CITY PLANNING COMMISSION

LOCATION: 4050 Taylor Street

PROPOSAL: The applicant is requesting the necessary entitlements to develop a 184 unit apartment complex on 7+ acres zoned for agricultural use.

APPLC. NO. P85-001

TYPICAL FRONT ELEVATION
 @ NORTH PROP. LINE

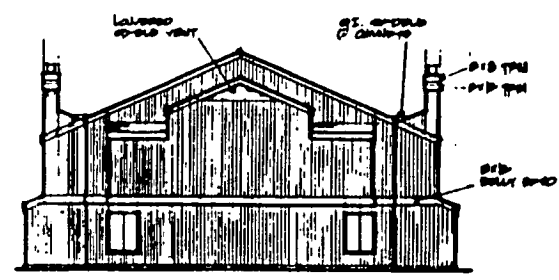
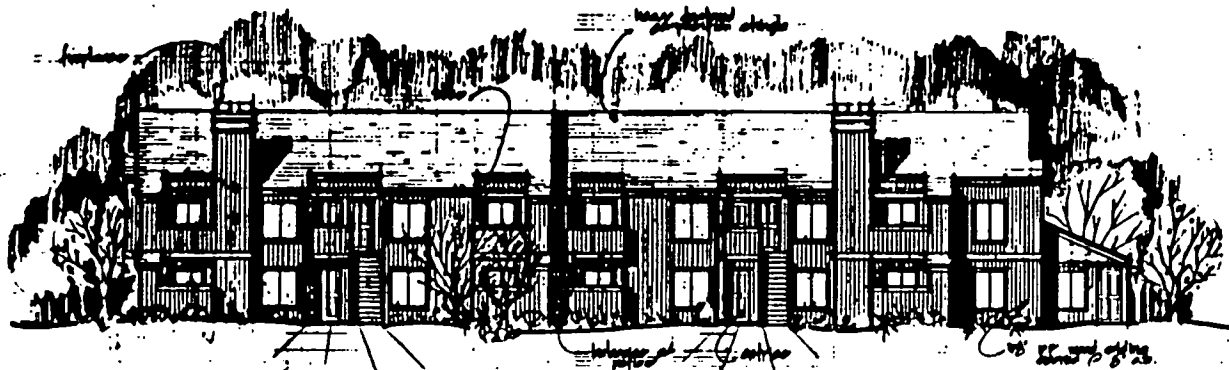
5. The applicant is proposing to use wood siding and stucco for the exterior finish of the units. The roofs are to be finished in composition shingles. Staff recommends the use of wood shingles or of a heavy textured composition shingle which provides depth and texture and will enhance the appearance of the complex.

7. The long rows of parking stalls on the south side of the site shall be interrupted with planter islands every 10th space.
8. Roofing material shall consist of wood shingles or a heavy textured composition shingle. Samples of any composition shingle to be used on the project shall be submitted to the Planning Director for review and approval prior to issuance of a building permit.

SITE STUDY PLAN

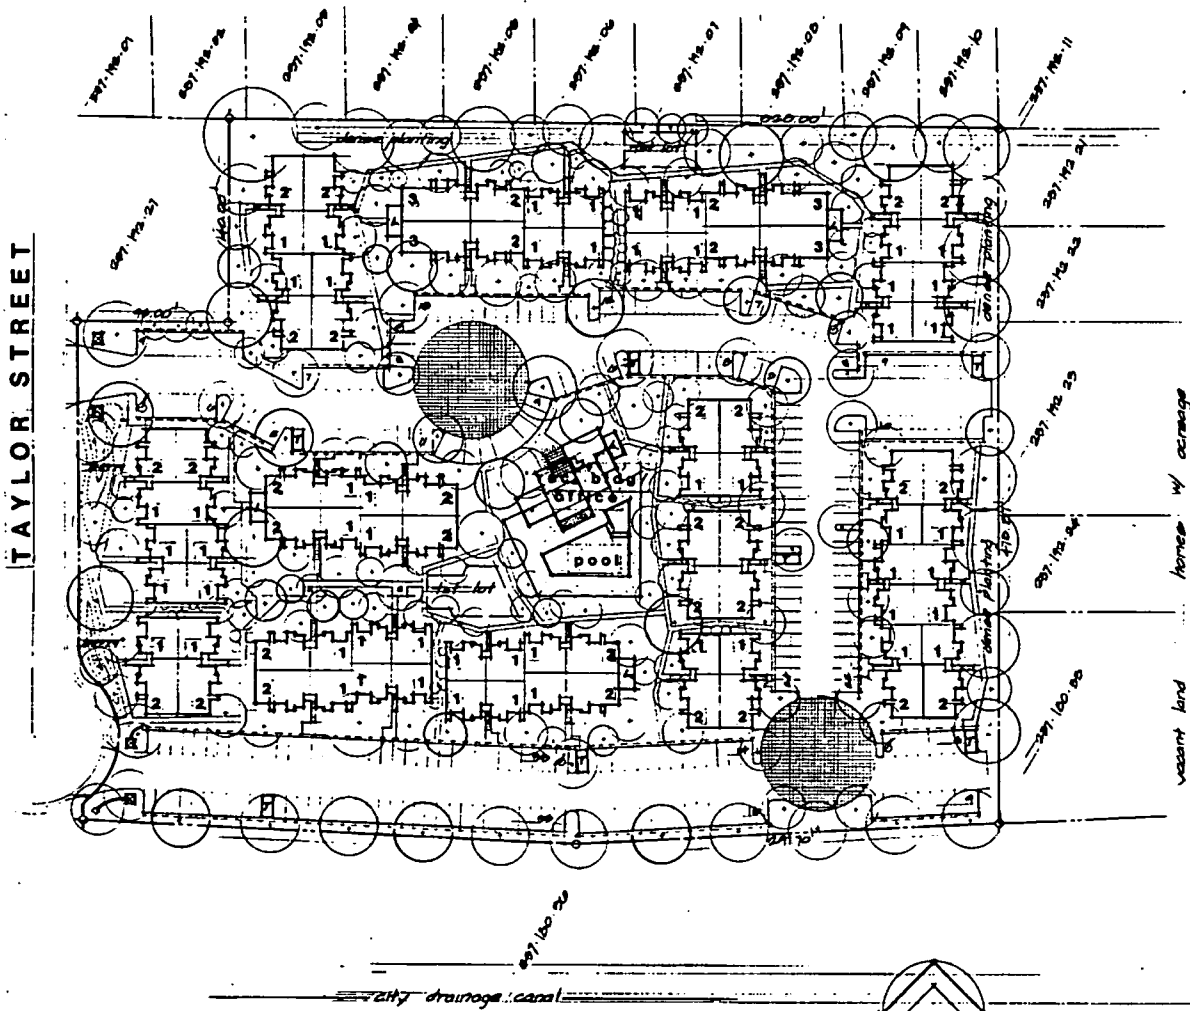
3. The front setback area has been bermed and landscaped with building setbacks varied from 20 to 45 feet. Staff does, however, recommend that the building on the south side of the site at the entry be set back to 25 feet. The building setbacks along the north property line, adjacent to the existing single family development, have been set back 40 feet for the units facing the north property line and 25 feet for those structures with side walled end units located adjacent to the neighboring single family development. The applicant has proposed a tot lot in the open area along the north property line. Staff recommends this lot be relocated since it may be disruptive to the adjacent single family residence. A solid masonry wall shall also be required along the north and east property lines. The south property line will require a sound wall to buffer noise from the freeway.

4. As proposed, on-site parking exceeds the requirement of 1-5 spaces per dwelling unit. Access to the parking is convenient to the individual units and it is not expected that on-street parking will result due to the parking design, number of spaces, and the configuration of the site. Staff does, however, recommend that the long rows of parking spaces on the south side of the site be broken up with planter islands every 10 spaces.

4. The tot lot on the north side of the site shall be relocated to the southerly portion of the site.
5. A 6 foot solid masonry wall shall be provided along the north and east property line.

2. The minimum building setback along Taylor Street shall be 25 feet.
3. All upper story balconies shall be enclosed with solid wood or stucco material.
